TR-105
ADSL2/2plus Functionality Test Plan

Issue: 1 Corrigendum 2
Issue Date: May 2011

The document contains corrections to TR-105 Issue 1.

Figure 7-1 REIN Noise for SES test

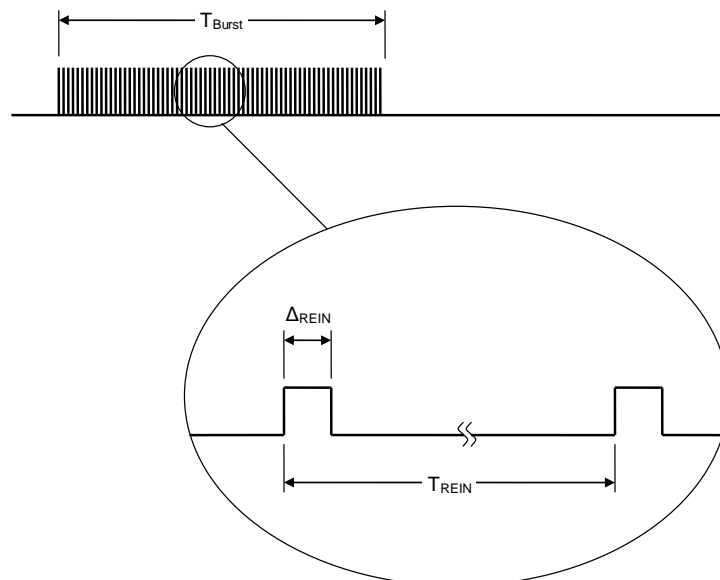
The test SHALL be done with bursts of the repetitive impulse noise (REIN) in addition to the background noise. The REIN noise duration is 690ms (T_{Burst}). The REIN pulse consists of a "Burst of pseudo random AWGN" at a level of –90dBm/Hz differential mode from 138 kHz up to 2.2 MHz, where the out-of-band noise shall not be higher than -140dBm/Hz. The pulse duration Δ_{REIN} depends on the specific test profile. The pulse SHALL be repeated every 10 ms (T_{REIN}).
